A Review of
London
Road Safety Audit
Procedures
and the cyclist

Including The Martin Way (B286) File

Compiled for the Merton Cycling Campaign
by Hugh Morgan

The Martin Way (B 286) chicane arrangement.

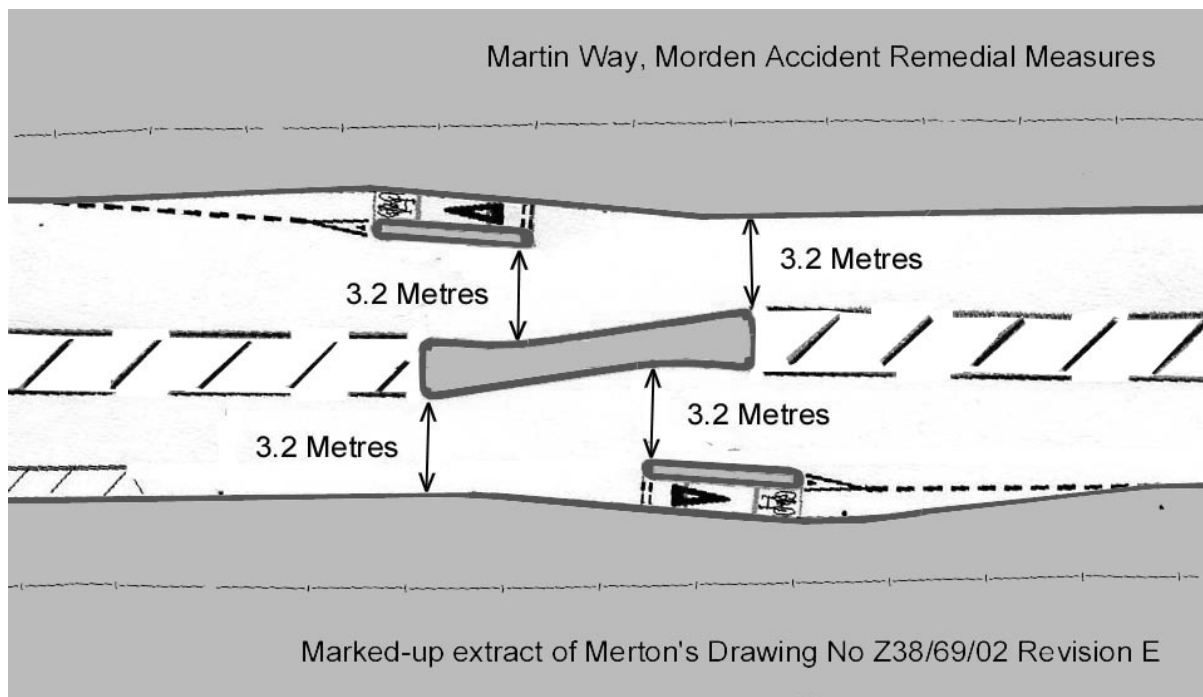
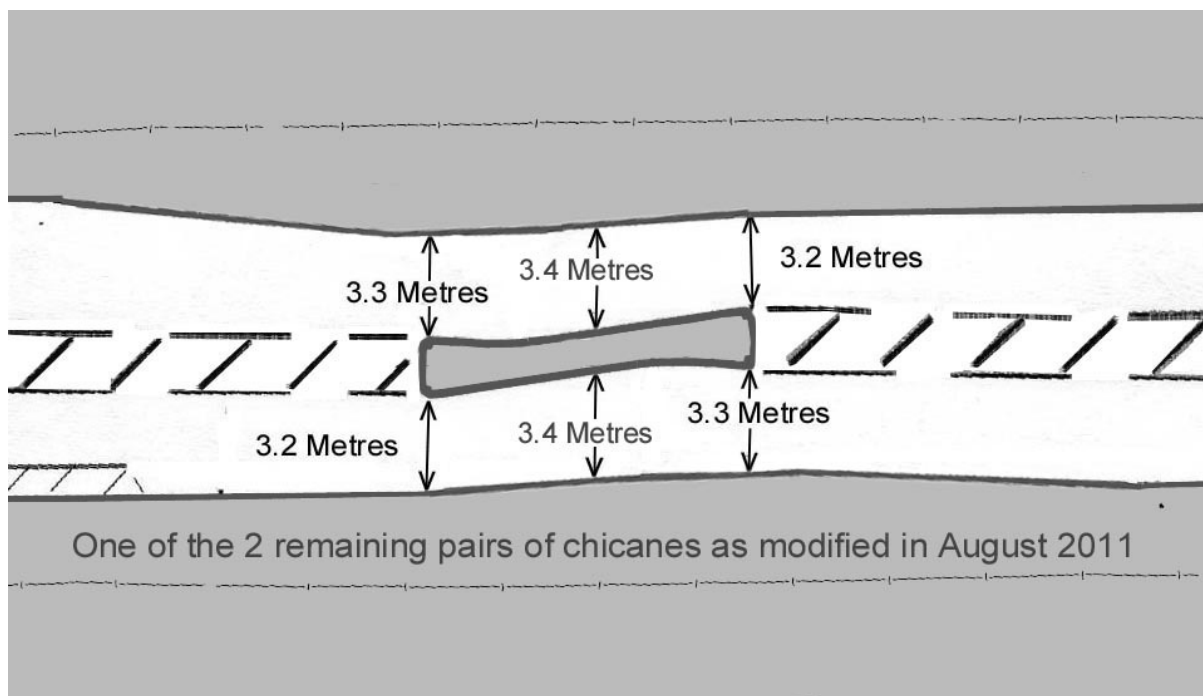
4.1.6 The present situation on the ground in Martin Way is that of the 10 traffic calming installations in 5 pairs (see **Fig.1 Appendix B**), which dangerously diverted cyclists into an impact position with late braking HGV's and Buses, 3 pairs have been removed entirely and returned to the road as before. After a further lapse in time the remaining 2 pairs were significantly modified in August 2011 (see **Fig.2 Appendix B**) but continue to be a serious risk to cyclists. Given Merton's admission of liability it is perhaps strange that their Insurers have not insisted on the complete removal of the final 2 pairs; The August 2011 modification has been carried out without a Road Safety Audit despite it being different to anything that was there before. It will however have warning signs which will answer one of Merton Cycling Campaign's long standing demands. The Insurer of course may take the position, promulgated by the diseased safety system described - that it is OK to take a risk with cyclists because cycling carries a risk.

4.7.1 TfL's Road Safety Auditors were in fact ,condemnatory of Merton's proposals for Martin Way. They concluded that at the first narrowing of the proposed chicanes (10 chicanes were proposed) the excessive speed of HGV's and Buses approaching the severe narrowing would result in vehicular strikes on kerb stones. This was confirmed in reality by kerbstones on the chicanes being completely smashed or dislodged. They argued that cyclists would also be in the line of fire because the cyclist's by-pass was too narrow and therefore might not be used. This inadequate and brief cycle by-pass happened to include a road hump exclusively arranged for the cycle by-pass which coincided with a stop sign before steering cyclists into the path of traffic at the second severe narrowing which had no by-pass! None of these gyrations seemed to bother the Road Safety Auditors despite the fact that a cyclist entering this system in busy traffic would have to be suicidal: forced to be prepared to halt in a destabilized position with measures to direct vehicles into the cyclist's path. These happen to be items i), j), and k) of the departures from the standards, listed in item 4.6.2 above, which the auditor should have been familiar with whether included in a list of departures from standard or not. It is possible that Merton's Audit Brief drawing was ineffective at showing the road hump. The road hump when in place caused ponding that meant that a stopped cyclist would be standing in a puddle and when the puddle was frozen it added to the danger.

4.7.4 The TfL auditor's error was to recommend that if Merton were to adjust a kerb by 50 millimetres (2 inches) then this would provide a narrowing of more suitable dimension to accommodate cyclists and motorists. This was wholly ridiculous advice. The dimension used by the TfL auditors came from

Fig. 1 As originally installed. Three of the pairs were removed completely in May 2010

Fig. 2 The two remaining pairs as remedied today
